Attachment 3 to AEP:NRC:0775AN

Attachment 4 to AEP:NRC:0775AN

SUBJECT: D. C. Cook Units 1 & 2
Technical Review of Differences in Tested and
Installed Configuration of Foxboro Pigtails

Donald C. Cook Nuclear Plant Units Nos. 1 and 2
Docket Nos. 50-315 and 50-316
License Nos. DPR-58 and DPR-74
ENVIRONMENTAL QUALIFICATION OF TORQUE SWITCHES

FIGURE 1. ELECTRICAL AND MECHANICAL INSTALLATIONS

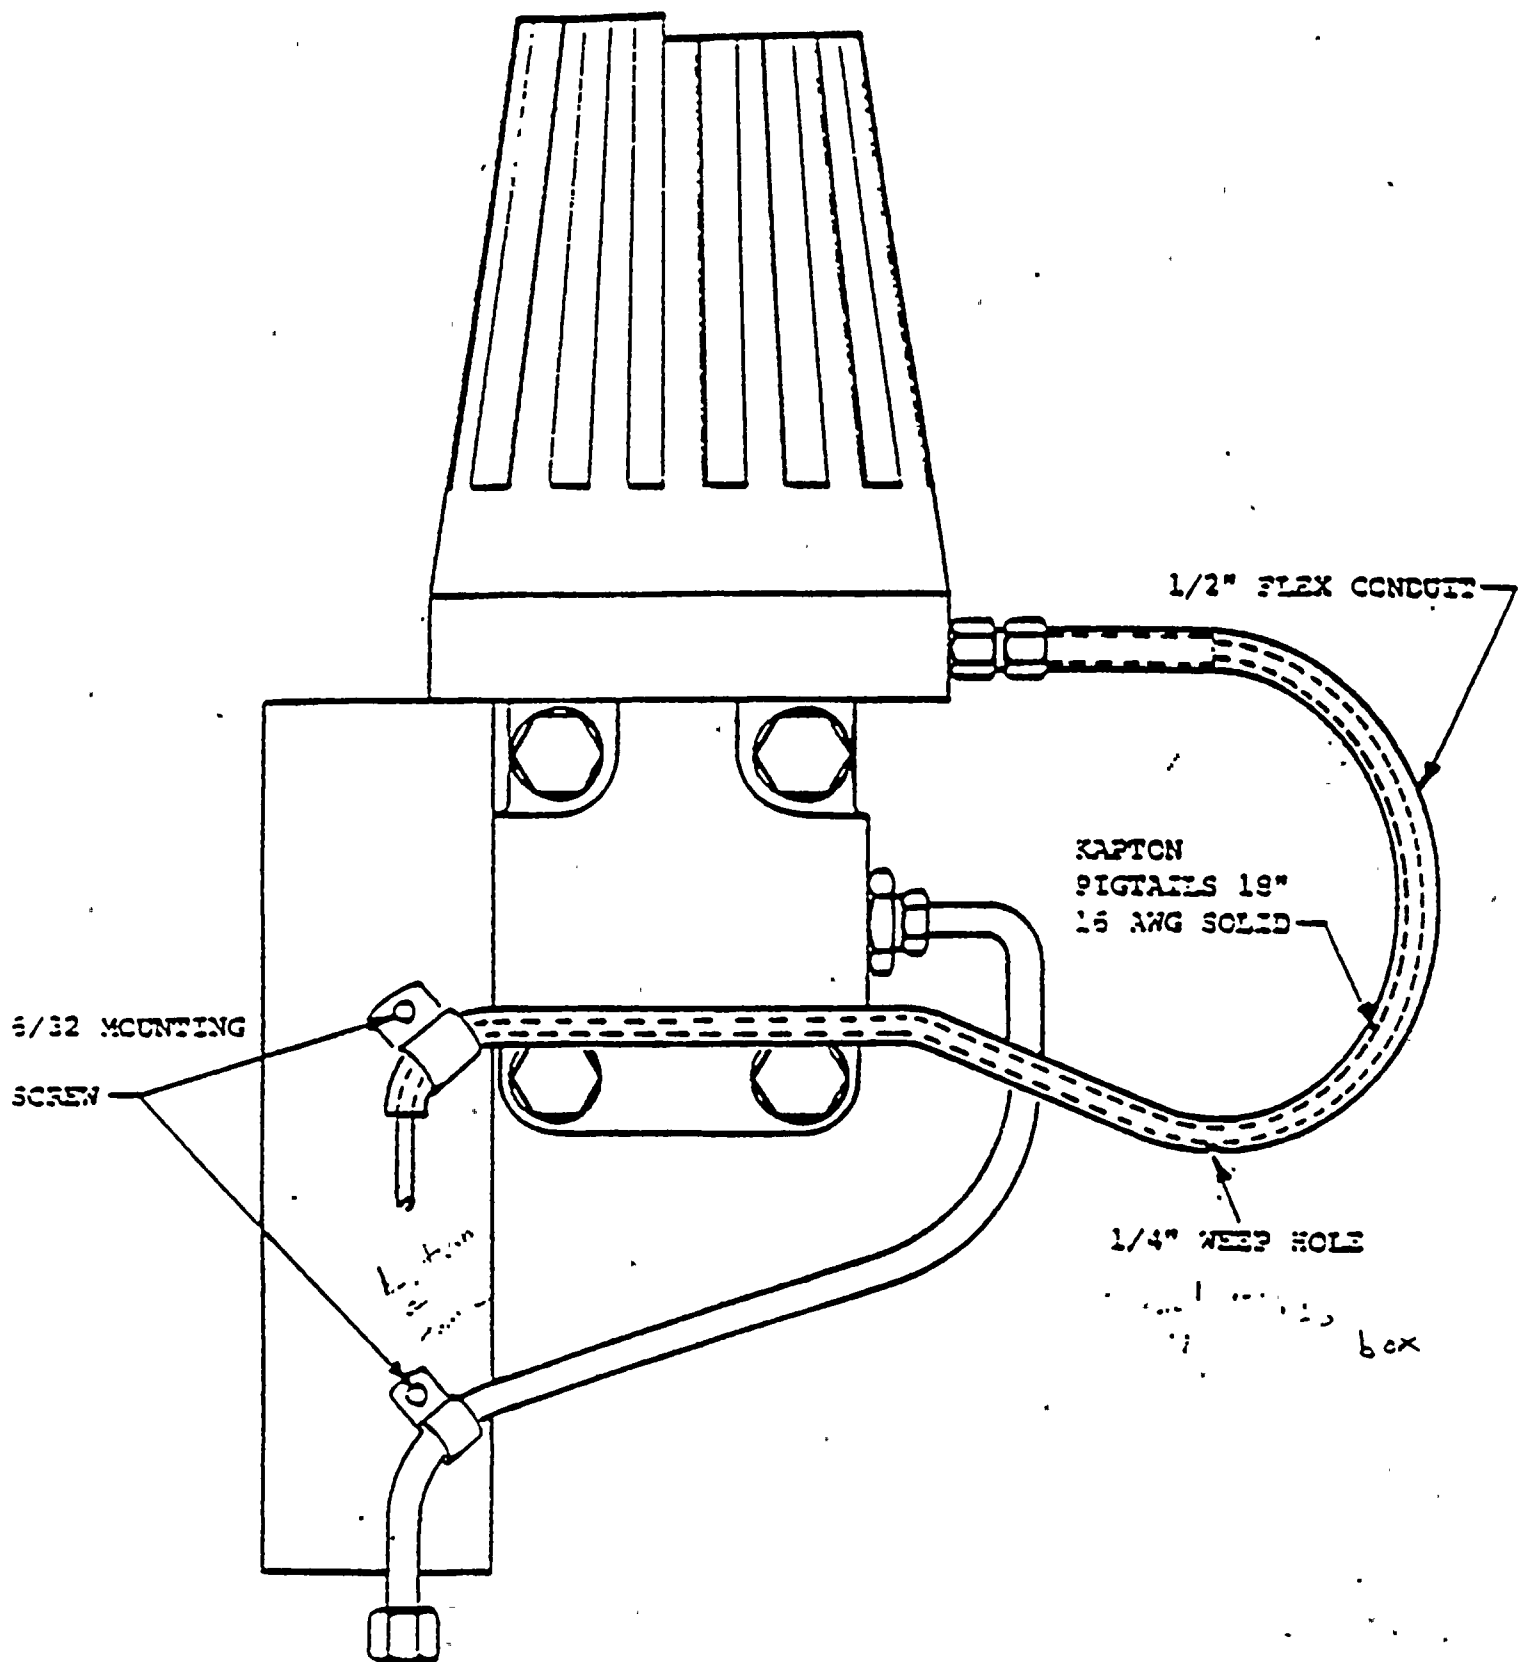
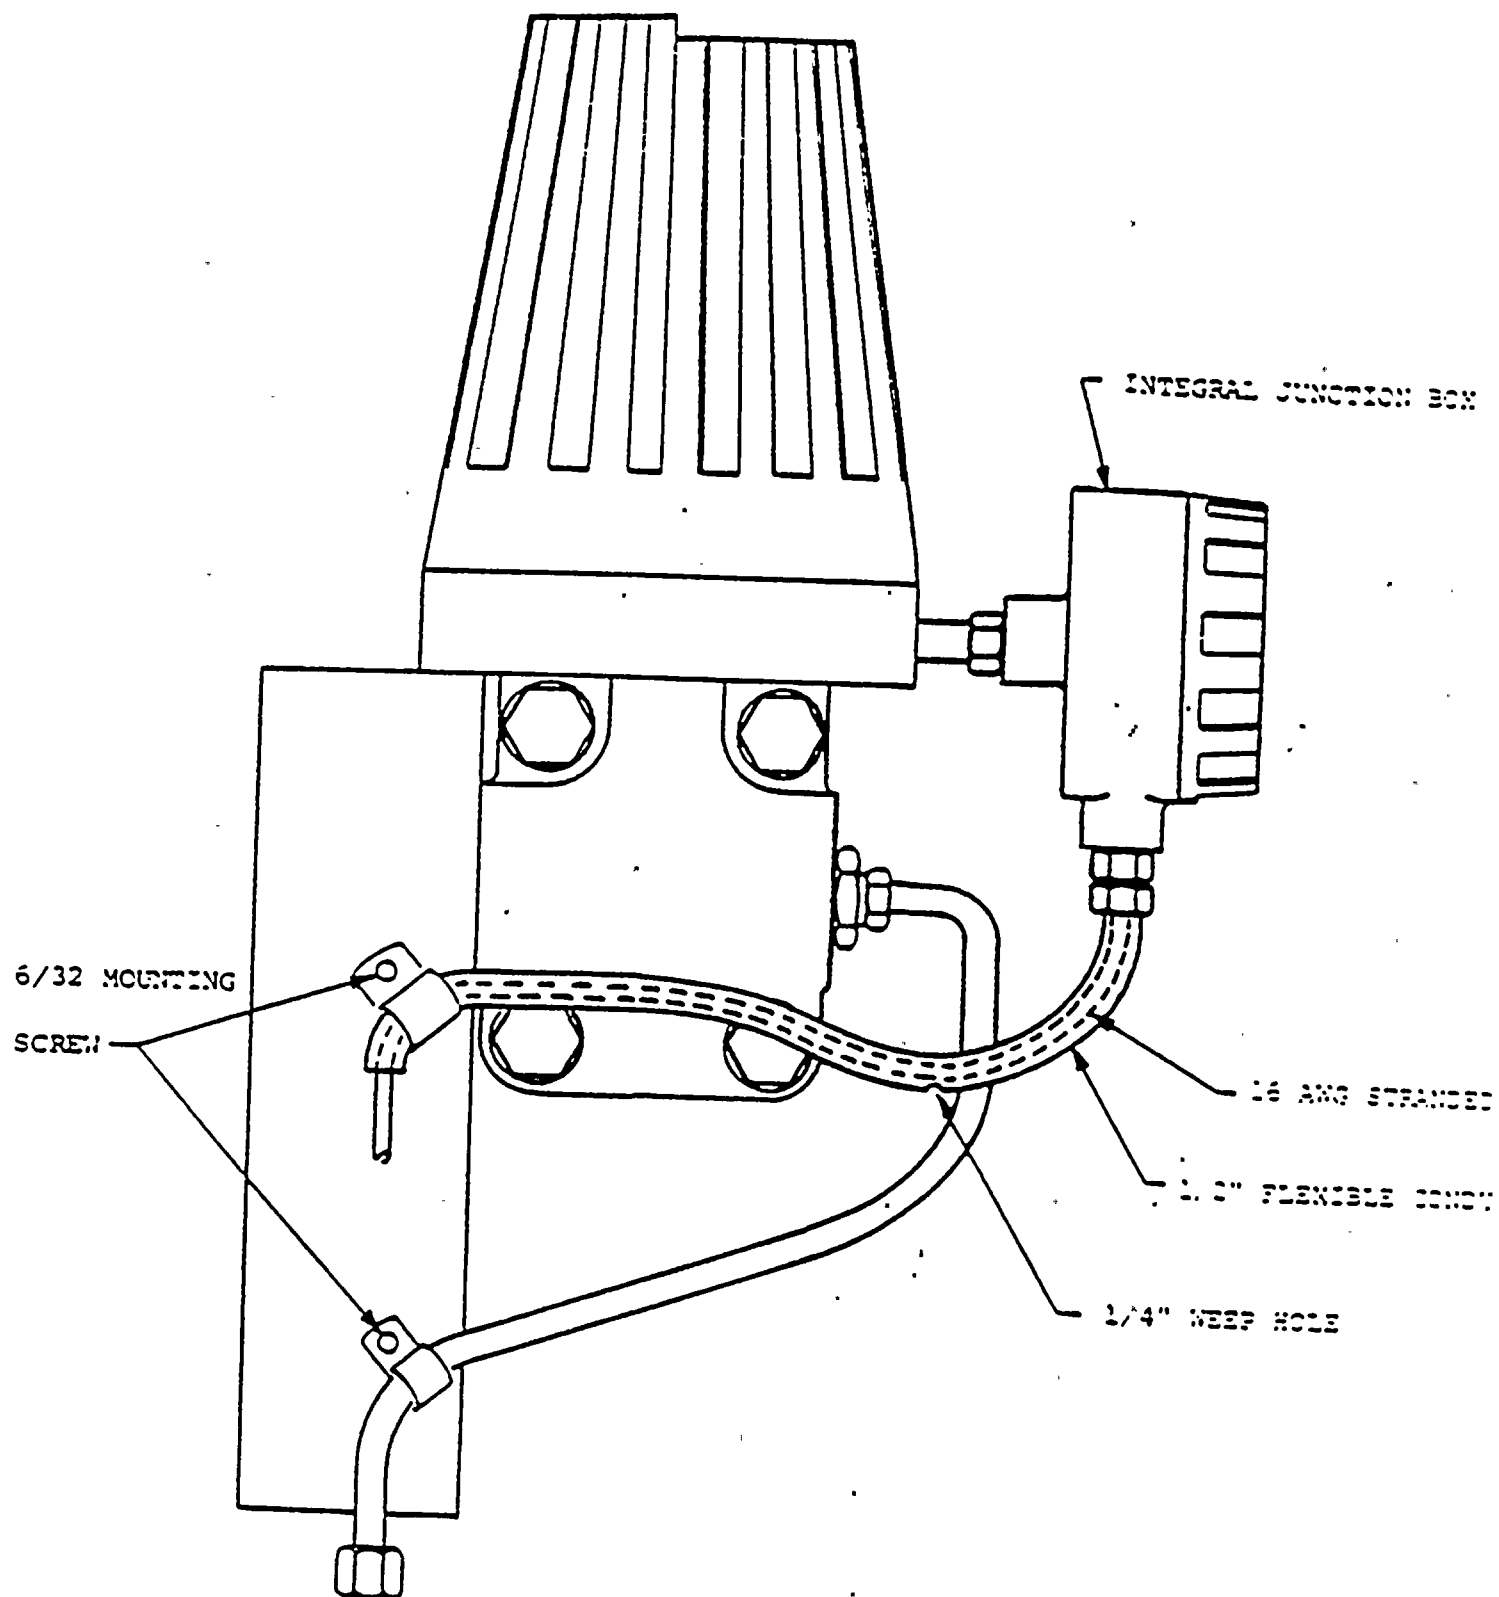
During the recent NRC audit of the DCCNP Environmental Qualification Program, it was noted that the DCCNP installed configuration of the Foxboro instrument pigtail conduit per PDS-1341 under RFC-01-2827 & 02-2828 was physically different than the tested configuration by the vendor in Wyle Test Report 45592-4. The tested configuration utilized a small 1/4" weep hole at a low point on a flexible metal conduit protecting the Foxboro instrument seal assembly pigtails. The weep hole was used to drain condensation near the instrument which may have accumulated inside the flex conduit during the simulated DBA test (see attached sketches).

Through conversations with Foxboro, it has been determined that the intent of the weep-hole was to avoid the "backing-up" of condensate from the chemical spray into the Integral Junction Box used in one of the two tested configurations. The integral junction box houses a terminal block which is known to be susceptible to leakage currents when exposed to chemical spray solution. The weep-hole design was carried-over to the second configuration which was used at D. C. Cook. The second configuration incorporates an internal instrument splice to a Conax seal assembly with no Integral Junction Box or terminal block installed. Therefore, the "backing-up" of condensate near the instrument seal assembly in the D. C. Cook configuration was of no significant concern.

Additionally, in both tested configurations the metal flex conduit looped back up after the weep hole and was routed down to a penetration at the bottom of the test chamber. The bottom end of the flex conduit was sealed which created a potential for the "pooling" of chemical spray condensate during the test. In this respect, the tested configuration is similar to what is hypothesized in the D. C. Cook Plant configuration.

In conclusion, we believe that the omittance of the weep-hole in the flex conduit near the instrument in the D. C. Cook configuration does not have a detrimental impact on the environmental qualification of the instrument, seal assembly or seal assembly pigtails. In addition, we believe that there is no significant functional difference between the tested and the D. C. Cook installed configurations of the foxboro instrument pigtail conduits.

PDS-1341-4

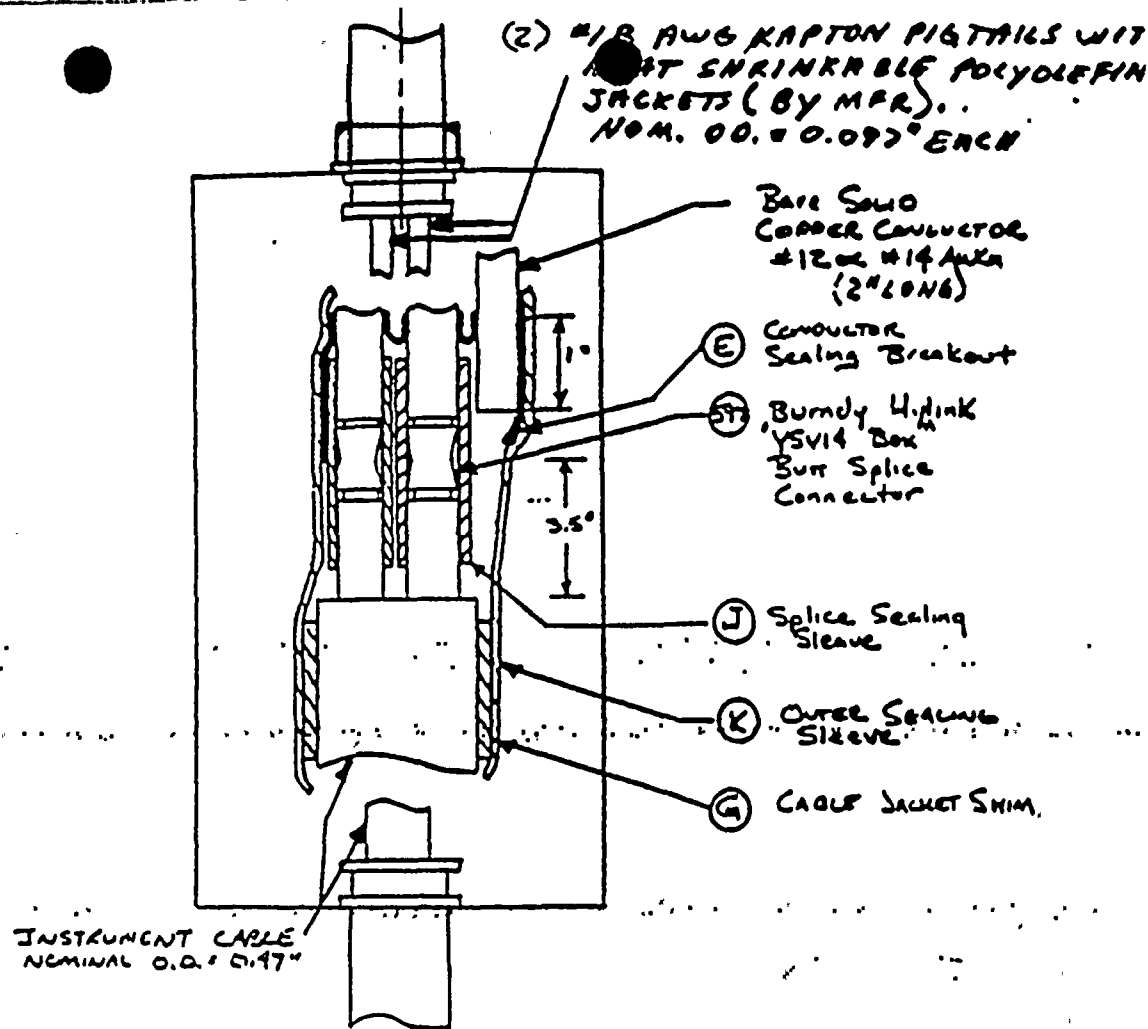
The DCCNP installed configuration incorporated the use of a sealtite flexible conduit plus the sealing of both the entrance and exit of the flexible conduit with an RTV silicone sealant. No provisions for a weep-hole were made for the DCCNP specific design. The applicable plant design standard for the installation of the instrument, pigtails, flex conduit, splice box, and pigtail splices is shown on drawing PDS-1341 (attached).

The hypothesized failure mode of the D. C. Cook configuration is that the PVC jacket on the flex conduit may fail during an accident near any elevated point on the conduit and allow steam to enter and condense. The condensation would then "pool" at the conduit low points, thereby subjecting the pigtails to possible submergence. The following paragraphs of this memo address this concern.

The potential for pigtail submergence failure is much less of a concern for the D. C. Cook configuration due to the following reasons:

- 1) It is not likely that the D. C. Cook sealed flex conduit configuration would fail in such a way as to create a harsher chemical submergence environment for the pigtails than what was tested. The type of submergence in the speculated D. C. Cook case involves a steam condensate and is not associated with containment flooding conditions. The steam condensate should theoretically be at a pH value which is less severe than the chemical spray exposure during the test.

- 2) The Kapton-insulated pigtail wires of the Conax Seal assembly are individually protected by the application of a heat shrinkable polyolefin jacket. The heat shrink tubing jacket significantly improves the ability of the pigtail wires to withstand chemical submergence by adding a protective layer of material over the Kapton insulation. Where applied, the protective layer of heat shrink reduces the exposure of the Kapton insulation to the condensate. The typical failure of Kapton insulated wire is due to an abrasion of the insulating material during installation combined with the effects of the chemical solution. The potential for abrasion or other mechanical damage of the Kapton insulation during installation at D. C. Cook has been essentially eliminated by the application of the heat shrink jacket.

- 3) The test report configuration, which exposed the Kapton insulated pigtails to the test chamber environment via the 1/4inch weep hole, demonstrates the ability of the pigtail wires to withstand harsh chemical conditions even without a protective heat shrink jacket.
